From: Hoellman, Jordan
Sent: Monday, November 14, 2016 9:50 AM
To: Vogle PEmails
Cc: Patel, Chandu
Subject: SNC Draft LAR-16-029, Classification of Nonsafety-Related Instrumentation
Attachments: DRAFT_SNC LAR-16-029_Non-1E Instr_Pre-Submittal Mtg.pdf

Southern Nuclear Operating Company
Vogtle Electric Generating Plant Units 3 and 4
Request for License Amendment:
Classification of Nonsafety-Related Instrumentation (LAR-16-029)

ND-16-2448

Classification of Nonsafety-Related Instrumentation

Figure 1: Safety Classification of Instrumentation Sensing Line, Manifold, and Instrument

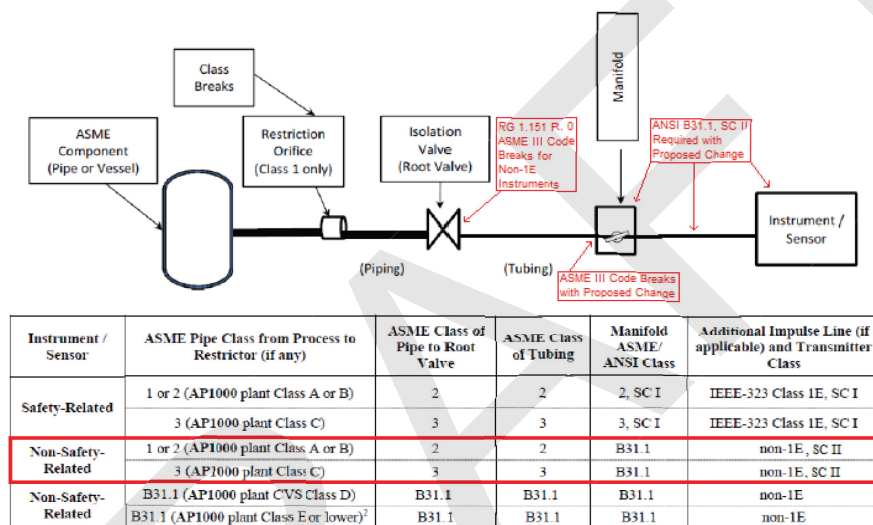
3.2.2.8 to describe that the instrument, manifold, and interconnecting tubing (additional impulse line) of nonsafety-related instruments that monitor safety-related pressure boundaries be classified as equipment Class D, seismic Category II. The instrument sensing line from the system piping to the manifold, including the instrument isolation valve, are proposed to be safety-related, seismic Category I. The equipment class applied to the safety-related portions is proposed to be the same as that of the monitored system, which is the same as for safety related instruments. The proposed changes are shown in the highlighted portion of Figure 1 below.

Note: section in red shows proposed changes, other sections are current classification methodology.

Plant-Specific Change	Description of Proposed Change
UFSAR Section 3.2.2.8	Revise to state that for nonsafety-related instruments interfacing with safety-related pressure boundaries, the instrument sensing lines and isolation valves have safety-related pressure boundary function, and the instrument manifold, sensor and interconnecting tubing are nonsafety related and seismic Category II.

Nonsafety-related instrumentation that monitors safety-related Class B or C fluid systems is Class D as defined in subsection 3.2.2.6. The instrument sensing line is safety-related, seismic Category I from the connected fluid system to the instrument manifold. The instrument, manifold and interconnecting tubing is Class D, seismic Category II, as defined in subsection 3.2.1.1.2. The Class D quality requirements include a pressure test at 1.5 times design pressure and a requirement for certified material test reports.
